Planning application reference: AL/107/21/PL

Woodgate Centre, Oak Tree Lane, Woodgate, PO20 3GU

Technical Note

Response to Committee Deferment Clarifications

Plan showing tracking during barrier closures

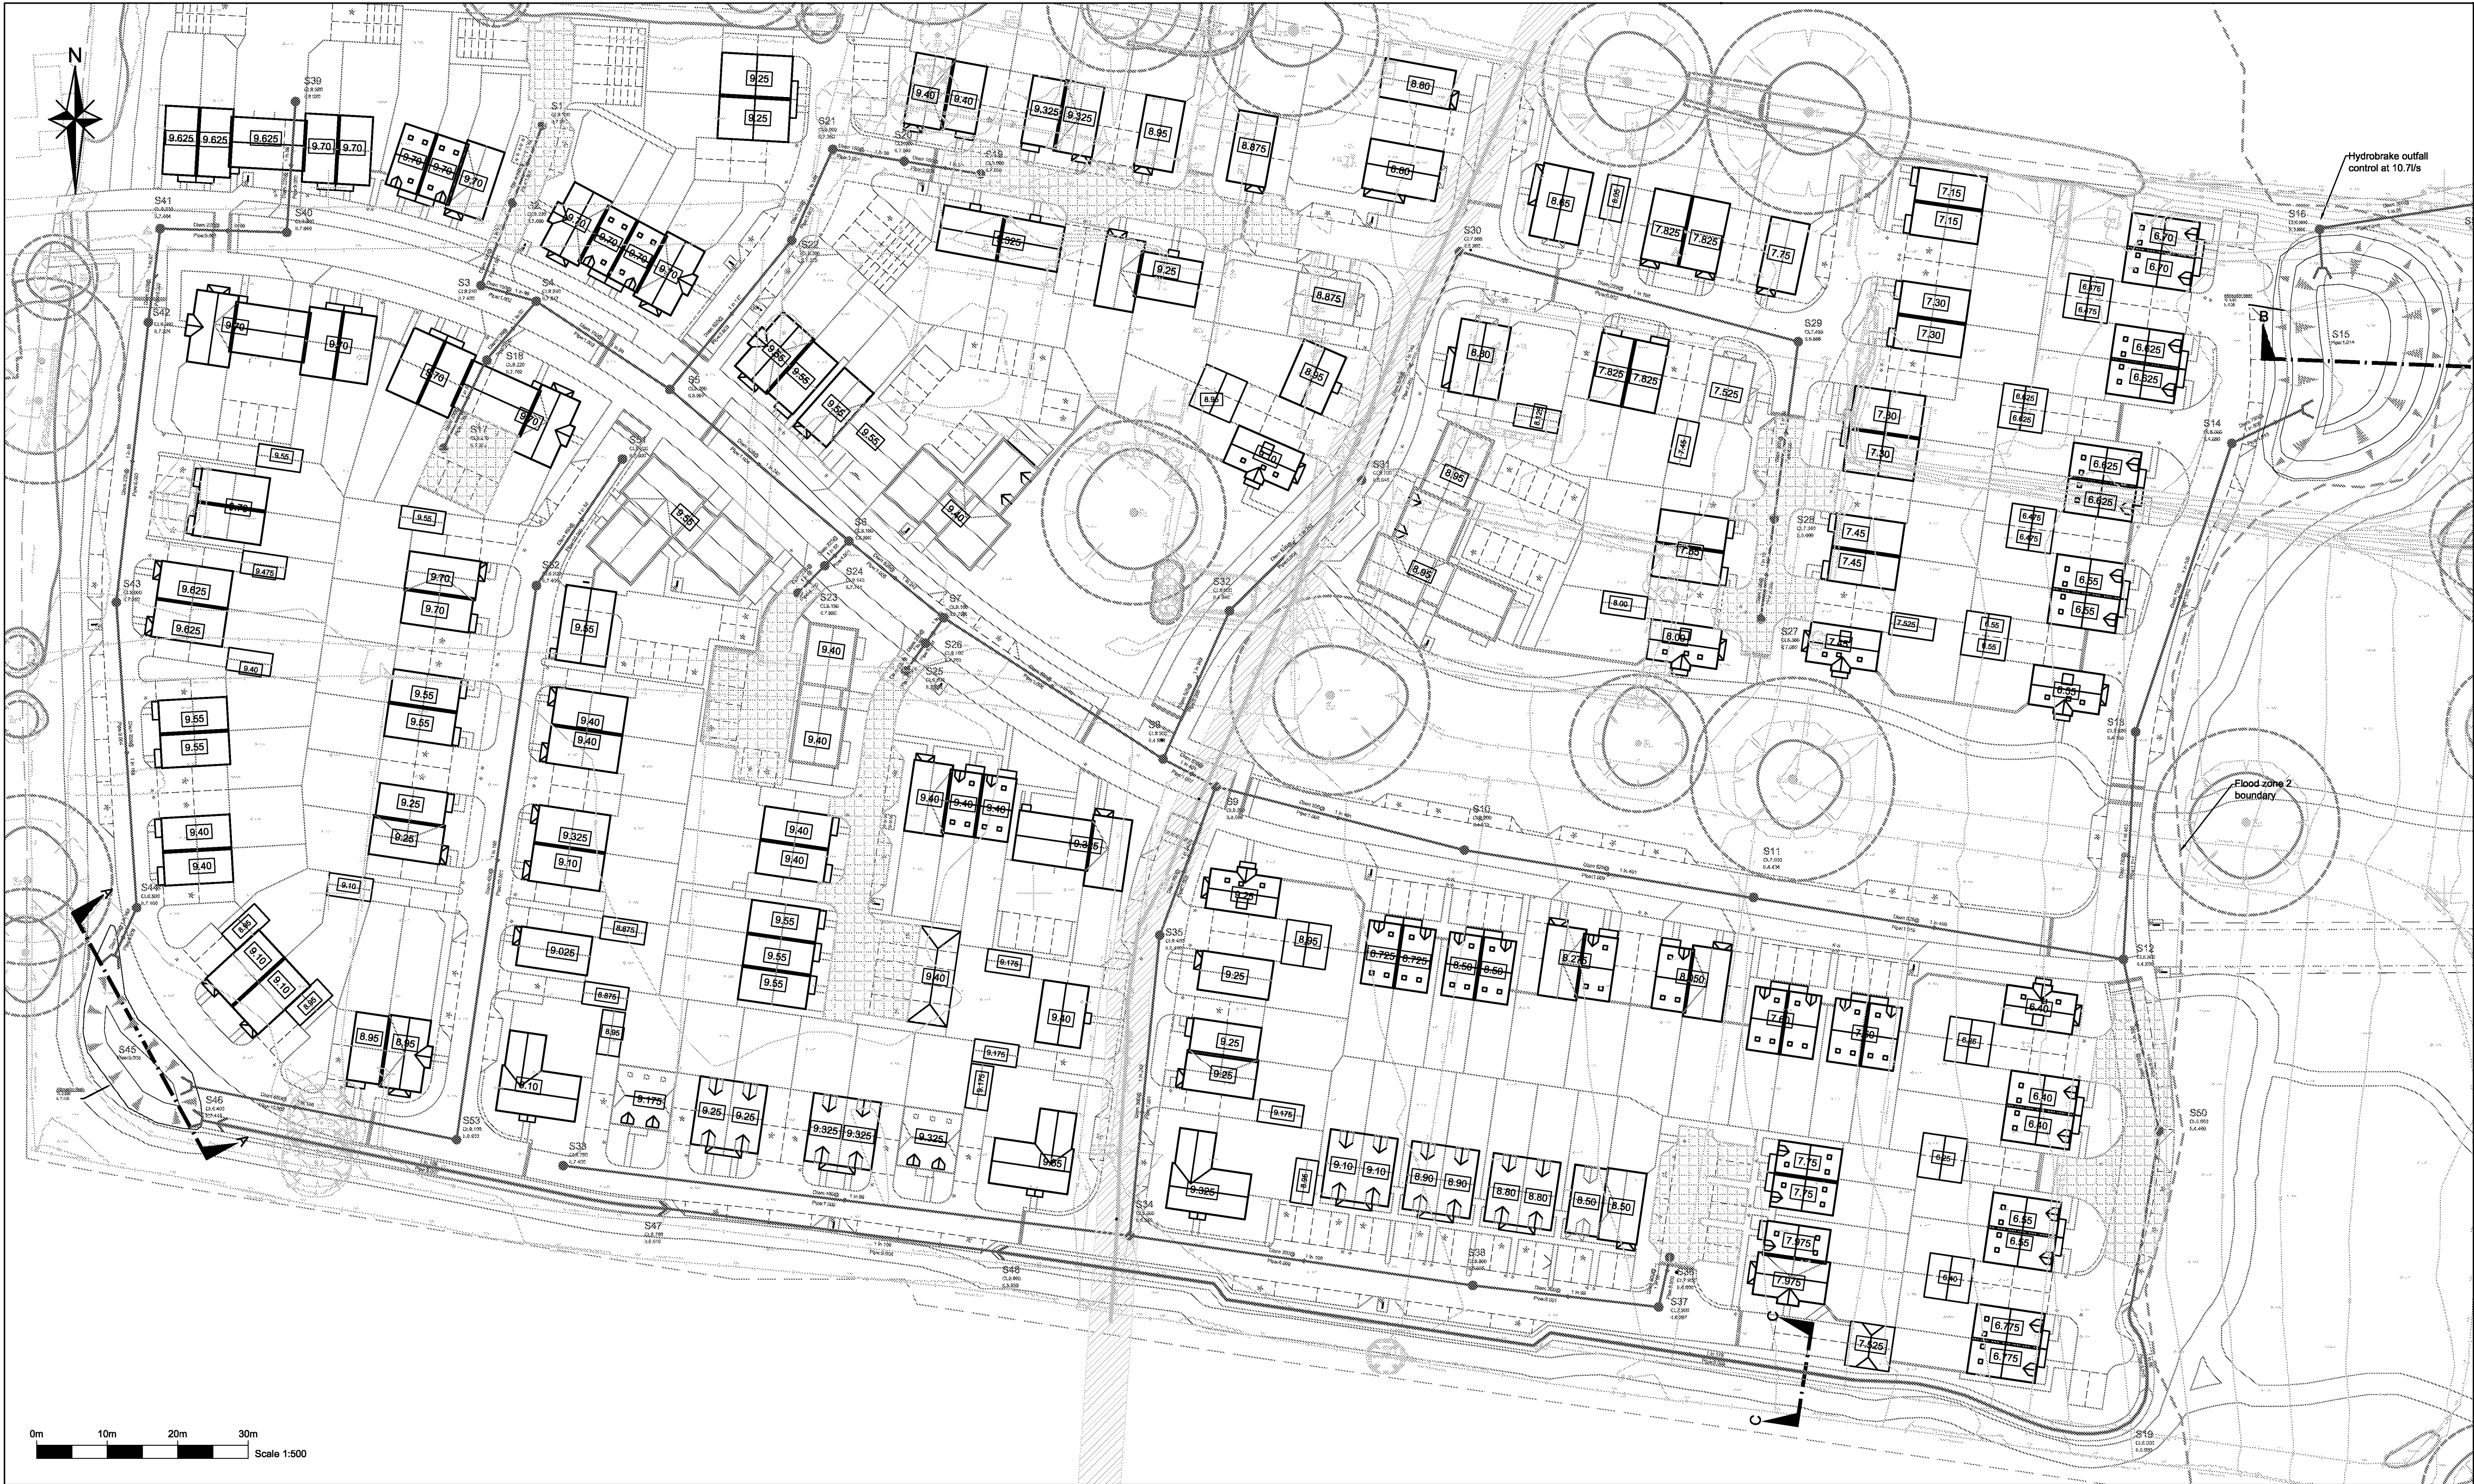
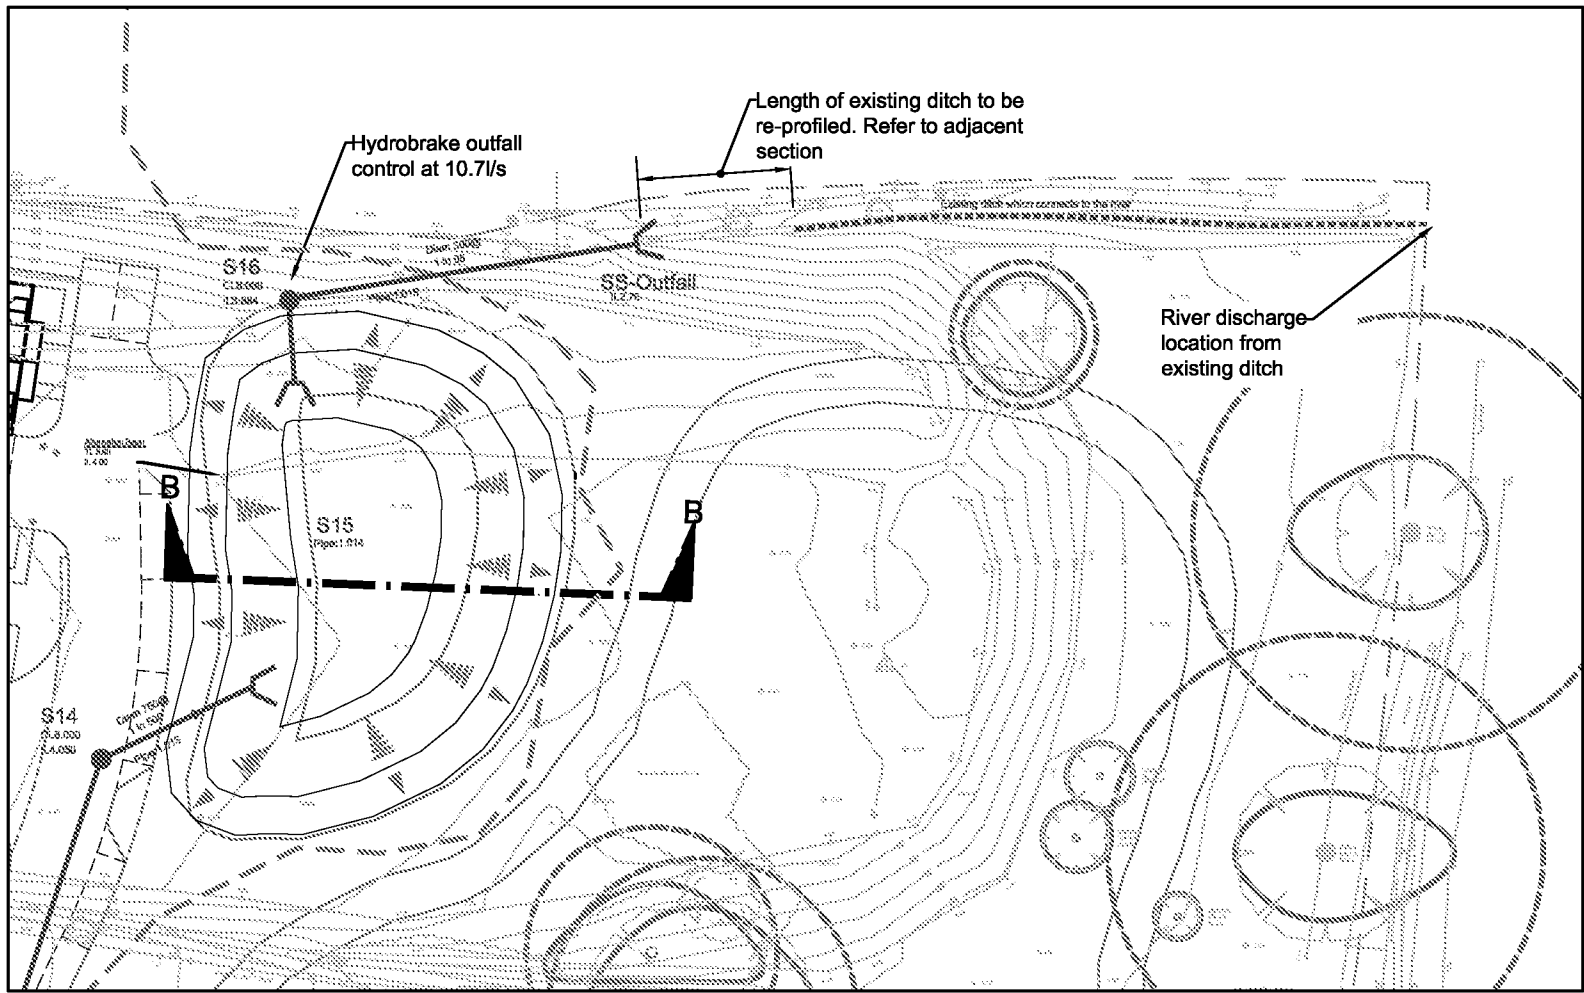
It is not in dispute that there is some existing on street parking close to the junction with Lidsey Road, which will have some implications on the efficient operation of this junction due to interactions with parked vehicles if the demand is sufficiently high. Particularly when the railway crossing barriers are operational.

Based upon the above it was estimated that during the periods when the level crossing gates are down and vehicles are prevented from exiting Woodgate Road, an average of 2 vehicles would be added onto Woodgate Road from the development. Acknowledging that trip departure profiles from residential developments are rarely uniform it is considered that, as an absolute worst case, a maximum of 5 vehicles might be added onto Woodgate Road during these periods. Although the likelihood of this is negligible. And if this does occur it would mean the queuing on the A29 would extend so far back past the Woodgate Road junction that it would not be possible to undertake the right turn manoeuvre in any case.

An indication of how Woodgate Road might operate in these circumstances in terms of interaction with opposing and parked vehicles is shown on **Drawing No. 20-061/040**, contained in **Appendix A**. It should be noted that the bell mouth radii for the junction have been increased to assist with vehicle movements in and out of the junction.

It is therefore anticipated that a slight increase in queuing on Woodgate Road may occur due to the inability of vehicles to exit the road to the north during periods when the level crossing is closed. It is considered that Woodgate Road would still maintain an operational state during these period. However, it is also highlighted that these are temporary conditions and queueing vehicles would disperse relatively quickly once the level crossing is re-opened.

No further parking until near junction with Woodgate Close (enough space for 8 cars to wait without blocking through traffic)

Parking as surveyed (typically 3 cars)
